Consideration of Comments

Project 2013-03 Geomagnetic Disturbance Mitigation

Figure 16 – Comparison of Metatech east-west geo-electric field calculation and NERC east-west geo-electric field calculation for May 4, 1998 storm event.

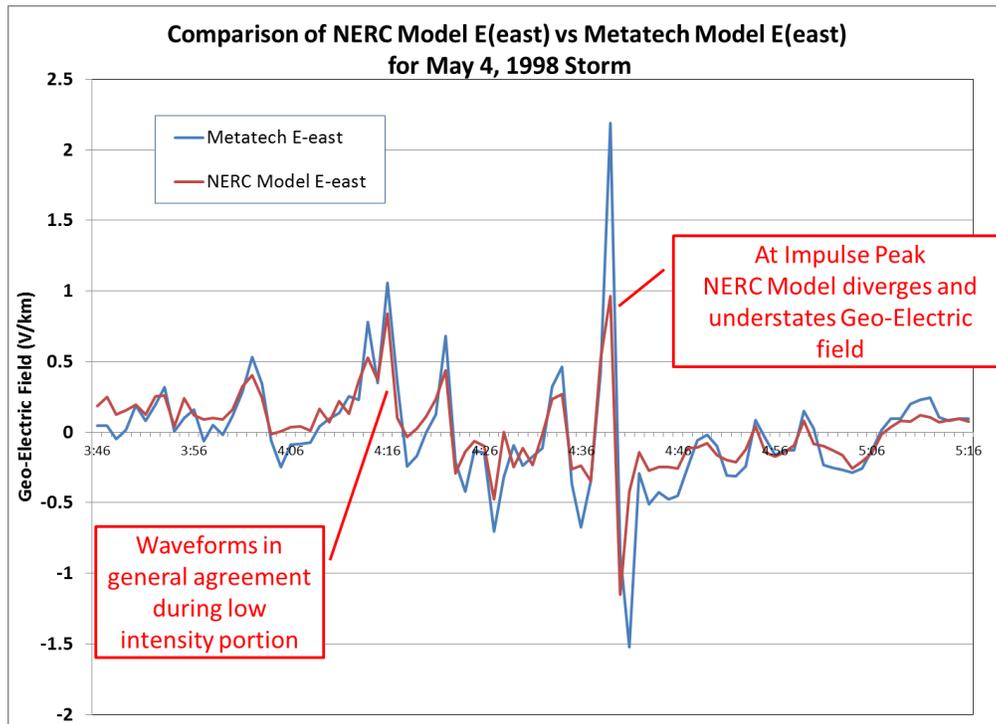
In the earlier portions of the storm simulation, the relative agreement between the two models for the geo-electric field is quite close. This occurs during a quieter and less intense portion of the storm. However as shown at the large impulse around time 4:39 UT, there is a divergence of agreement between the two models with the NERC modeling method understating the Metatech model results by a significant margin. After that impulse is over, the two models again come into relatively close agreement again. This suggests a problem in the NERC model of understating the intensity for more intense impulsive disturbances. As previously shown, the intensity in dB/dt is ~ 600 nT/min at time 4:39 UT, while it is generally below 100 to 200 nT/min at all other times during the simulation. Hence this higher intensity may be an important inflexion threshold within the NERC model.

Figure 18 - Comparison of NERC model GIC to observed GIC at Chester.

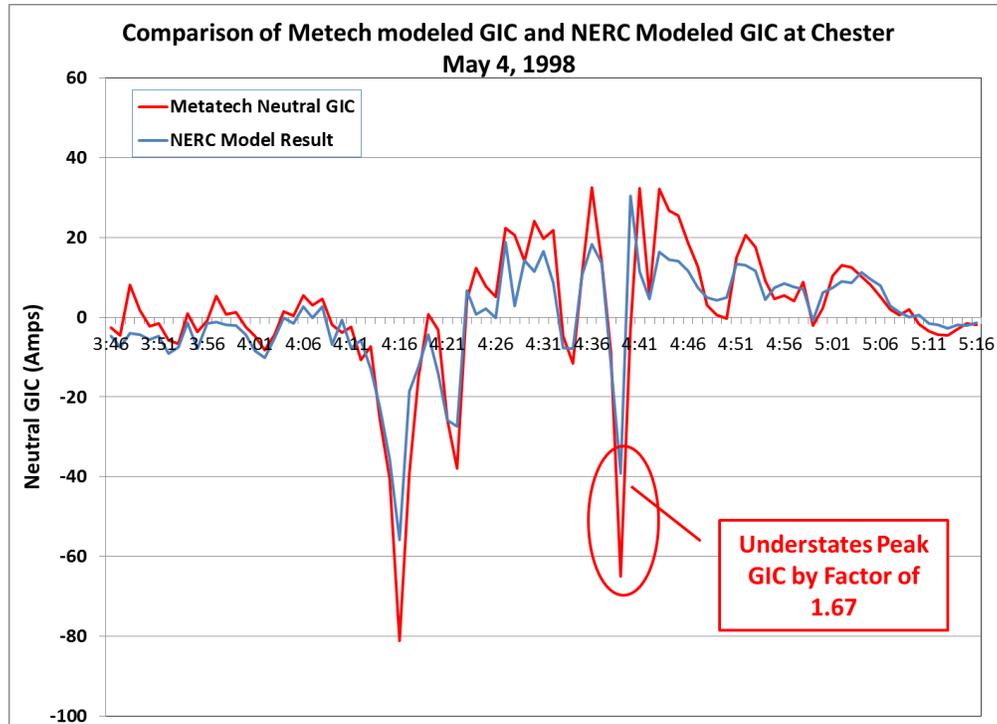
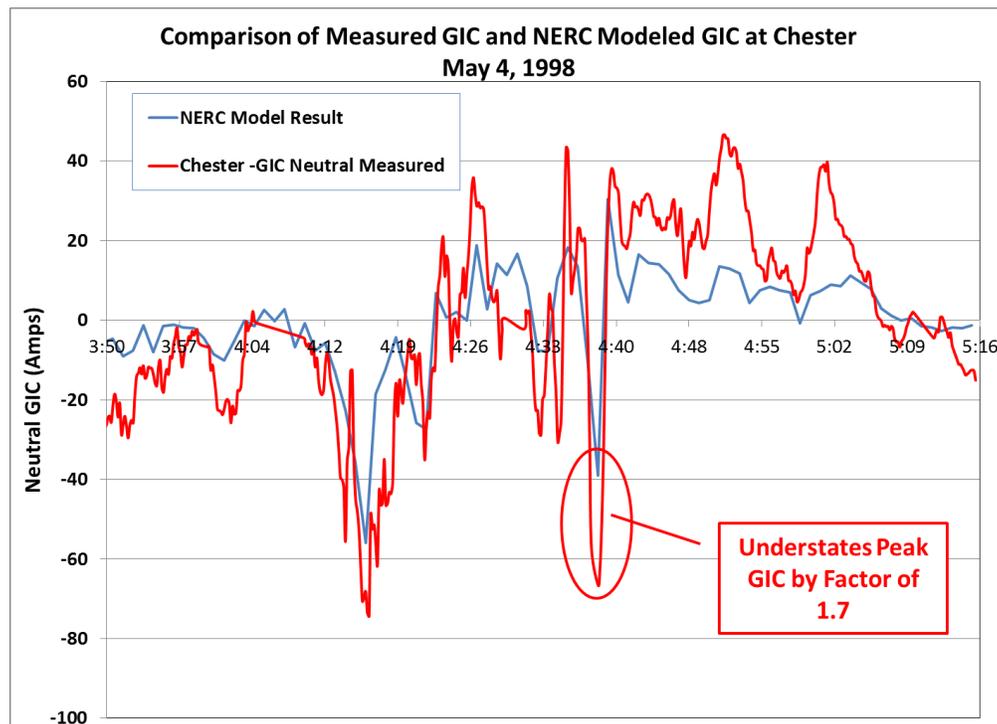
As previously discussed Ohm's Law requires a sufficiently large enough geo-electric field to create the GIC flow observed at this location. Using the NERC model geo-electric fields it is possible to calculate the GIC flow and compare this to the GIC flow calculated for the Metatech model and even to the observed GIC. Figure 17 provides a comparison of the NERC model GIC with that computed in the

Metatech model. Figure 18 compares the same NERC Model GIC result with actual GIC observed at Chester. As both of these figures illustrate, the NERC model results will under predict the GIC at the peak storm intensities. In the case of the peak at time 4:39UT the understatement was similar in both the model comparisons and the observed GIC comparison.

Figure 22 – NERC Model estimated East-West Geo-Electric Field on July 15, 2012 for the NE1 ground model.

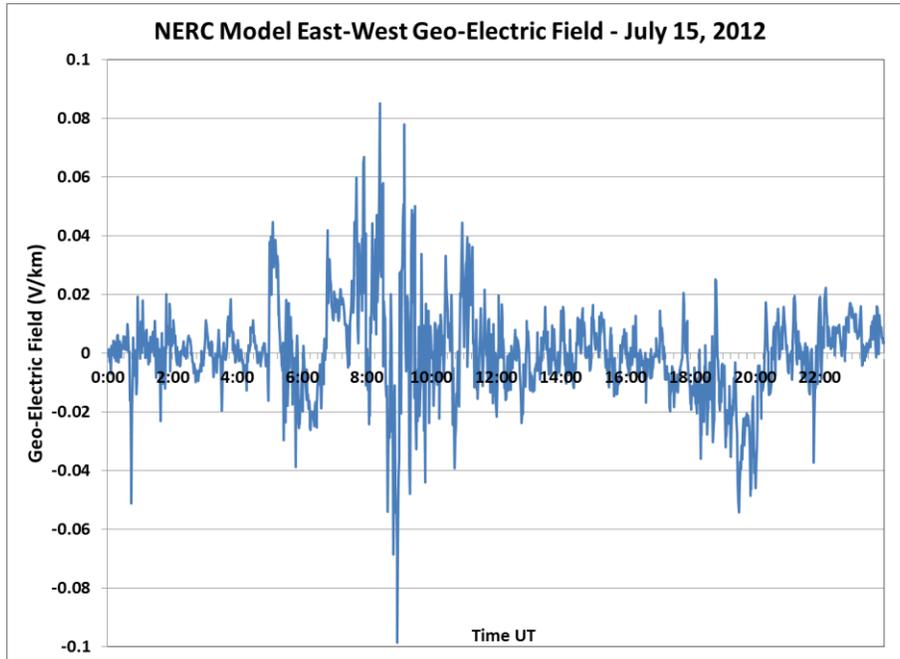
Figure 22 provides a plot of the East-West Geo-Electric Field that would be derived using the NERC model from this storm, using the Ottawa observatory geomagnetic field disturbance conditions as the input. As shown the peak field intensity reaches only ~ 0.1 V/km which is ~ 4 times too low to produce the actual GIC observed at Seabrook for this storm event. Hence this storm simulation model provides an example of even worse GIC validation attempt than at Chester. (Not shown is that the peak north-south geo-electric field would have been ~ 0.12 V/km. But these are also too low and would not couple efficiently with the Seabrook region circuits; therefore this was not a factor in the GIC levels at Seabrook.)

Figure 27 – Comparison of NERC Model geo-electric field with estimated geo-electric field needed to produce Tillamook GIC flows for the Oct 30, 2003 storm

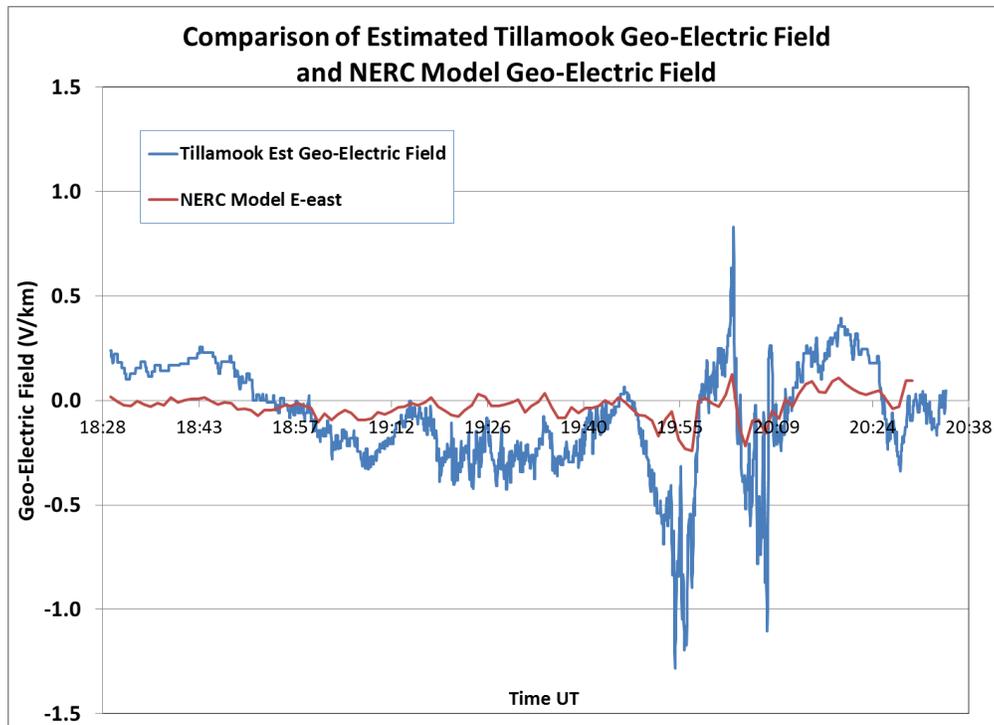
As Figure 27 shows, the peak geo-electric field as strictly constrained by Ohm's law must exceed 1 V/km during portions of the GIC flow where the Tillamook GIC exceeded ~38 amps level. At all times, the NERC model geo-electric field did not exceed even 0.25 V/km. As this comparison illustrates, the NERC model greatly understates the peak geo-electric field intensities at the peak GIC flow portions of the storm. In some cases this understatement is more than a factor of 4 to 5 times too small. This degree of divergence is also worse than what was observed at Chester Maine and is similar to the error level noted for Seabrook.

Figure 30 - Comparison of NERC Model geo-electric field with estimated geo-electric field needed to produce Tillamook GIC flows for the July 15, 2000 storm

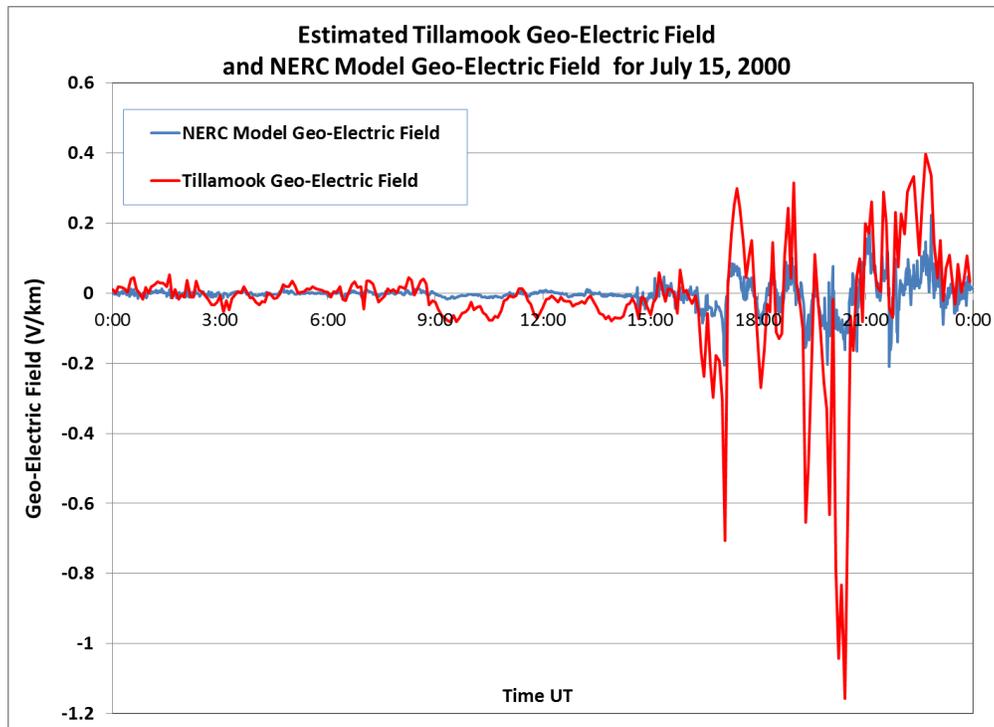
From the GIC observations for this storm, the minimal Geo-Electric field levels necessary to produce the GIC flows observed at Tillamook can be again calculated. This can also again be compared with the estimates used by NERC in modeling this storm event, this comparison is shown in Figure 30. In the comparison of the NERC model geo-electric field with the actual geo-electric field as derived from GIC measurements, the NERC model again greatly under predicts peak V/km intensities, by as much as a factor of ~5 or more at peak intensities times. These results are similar to the results from the Oct 30, 2003 storm as shown in Figure 27 and further confirm that the NERC models will not accurately depict storm conditions.
